Work Order ID 142047

Item Name: Replacement Skidtube.High Gear with Standard Wearplates Fits LH or RH

DRAWING NO. D2650	TITLE 206/407 SKIDTUBE ASSEMBLIES	REV. F	DART AEROSPACE LTD ENGINEERING ORDER		D.E.O. NO. D2650-F-1	SHEET NO. SHEET 1 OF 1	SCALE NTS
DRAWN <i>AP</i>	CHECKED <i>AP</i>	MFG. APPR. <i>AA</i>	APPROVED <i>HA</i>		DE APPR. <i>HA</i>		
DATE 12.10.12	DATE 12.10.22	DATE 12.10.22	DATE 12.10.22		DATE 12.10.22

CHANGE C'BORED WELDED CROSSBOLT SPACERS TO SWAGED SPACERS

AMENDMENT TO DETAIL B
NOT TO SCALE

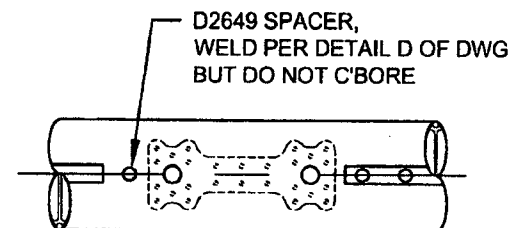
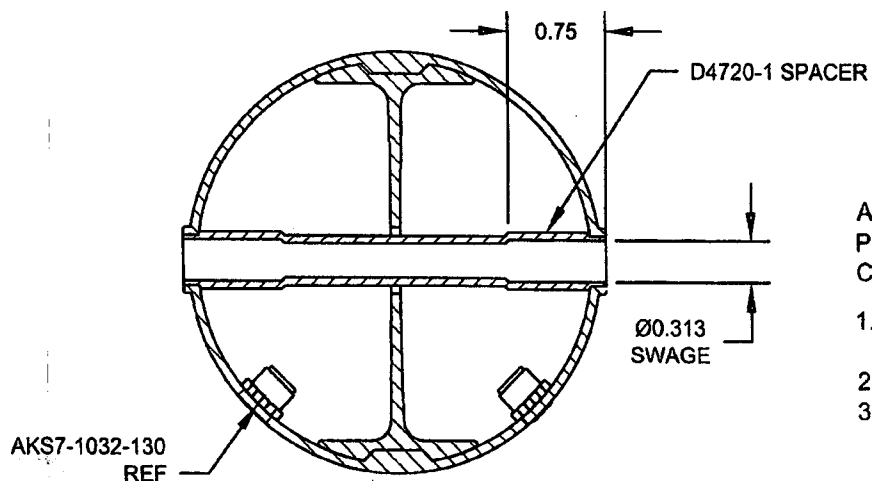
ADD DETAIL G BELOW, WHICH IS THE SAME SECTION VIEW AS DETAIL D OF DWG.
C'BORED HOLES ARE **NOW SWAGED** PER DETAIL G BELOW. FOR THE Ø0.375 HOLE THAT IS NOT C'BORED, WELD PER DETAIL D OF DWG (SEE AMENDED DETAIL B FOR REFERENCE).
